Model:Triton-C1 Punch Unit(Hole Punch Unit Type 3131)		Date: 2-Aug-05	No.: MB734001
Modified Article: Bracket / Stay		Prepared by: M. Tsuyuki	
From: 1st Tech. Support Sec. Service Support Dept.			
Reason for Modification:	☒ Parts catalog correction ☐ To facilitate assembly ☐ Part standardization	☐ Vendor change ☐ To improve reliability ☐ Other	☐ To meet standards ()

Model: Triton-C1 Punch Unit (Hole Punch Unit Type 3131)		Date: 10-Aug-05	No.: MB734002
Modified Article: Bracket / Stay		Prepared by: M. Tsuyuki	
From: 1st Tech. Support Sec. Service Support Dept.			
Reason for Modification:	☒ Parts catalog correction ☐ To facilitate assembly ☐ Part standardization	☐ Vendor change ☐ To improve reliability ☐ Other	☐ To meet standards ()

Part Change Information List

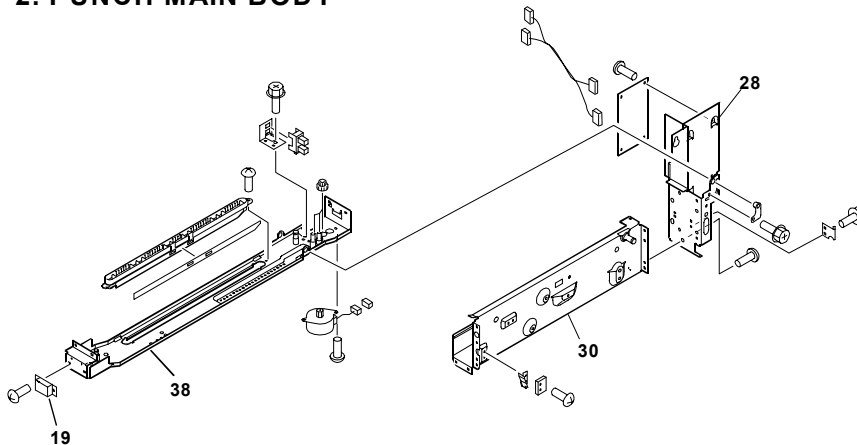
Change/Reason: The Parts Catalog was corrected as follows.

Old part number	New part number	Description	Q'ty	Int	Page	Index
B7341116	B7341516	Catch Magnet (4407837720) Bracket (44210658000)	1	X/O	5	19
B7341134	B7341534	Bracket (44210016000) Bracket (6LE68046000)	1	X/O	5	28
B7341124	B7341524	Bracket (44210658000) Stay (6LE67300000)	1	X/O	5	30
B7341132	B7341532	Frame (44210658000) Frame (6LE68046000)	1	X/O	5	38
